WSN9- Replacing Plastic Slide On Three-Point Front Seat Belt (Workshop Campaign)

Model Year: **As of 2024 up to 2026**

Model Line: **Macan (XAB)**

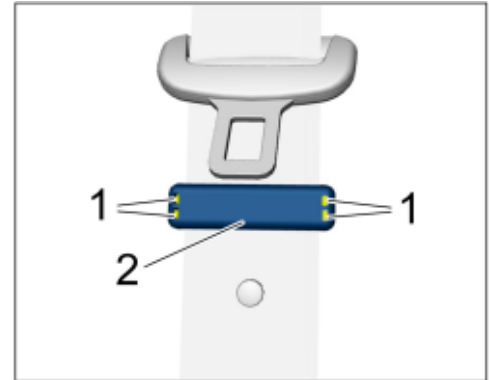
Cause: **On the affected vehicles, there is a possibility that on the passenger side rattling noises could occur on the B-pillar due to the free-swinging belt tongue of the three-point seat belt.**

Action: Replace plastic slide on the three-point seat belt on the passenger side with a plastic slide with belt loop.

Plastic slide without belt loop

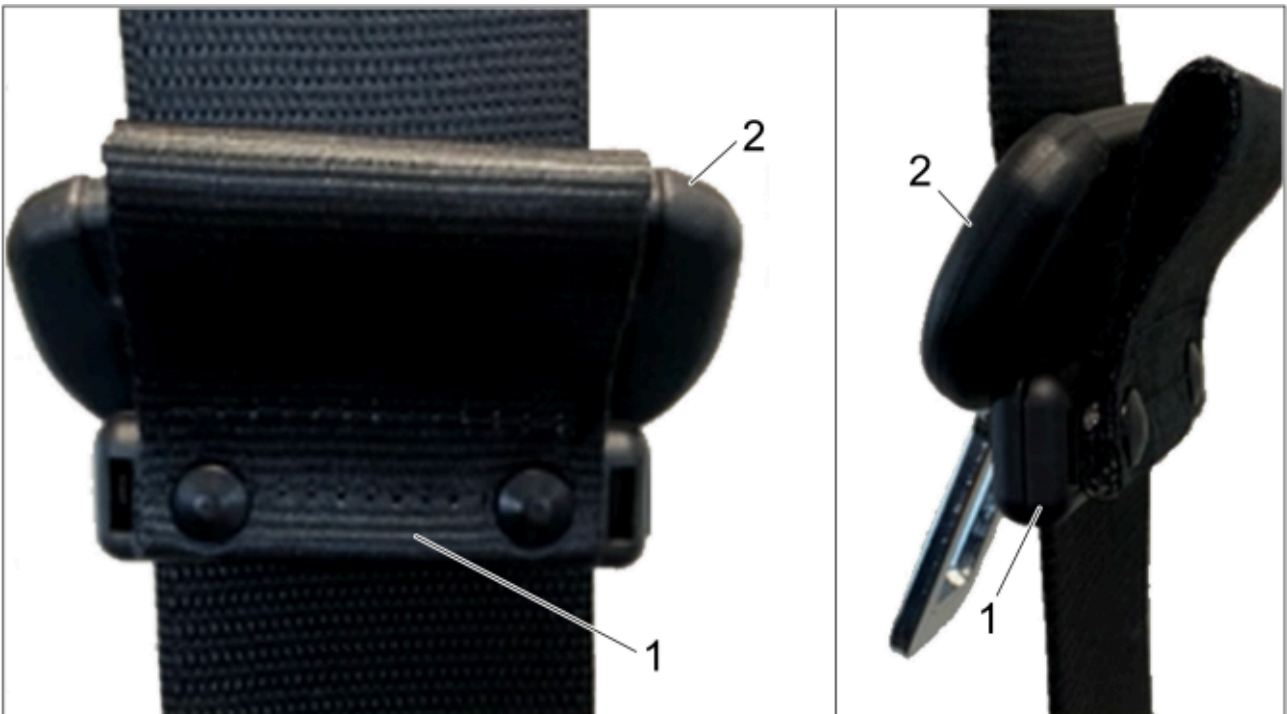
- Work Procedure:
- 1 Loosen retaining lugs \Rightarrow *Plastic slide without belt loop -1-* on the plastic slide \Rightarrow *Plastic slide without belt loop -2-* using a suitable tool, \Rightarrow *Plastic slide without belt loop -2-* open plastic slide and remove.
 - 2 Fasten **new** plastic slide with belt loop \Rightarrow *Plastic slide with belt loop -1-* to belt strap. Make sure that the belt loop under the belt tongue is pointing \Rightarrow *Plastic slide with belt loop -2-* upwards.

- 3 Fasten the removed plastic slide **without** belt loop to the three-point seat belt on **the passenger side**.
- 4 Enter the campaign in the Warranty and Maintenance logbook.
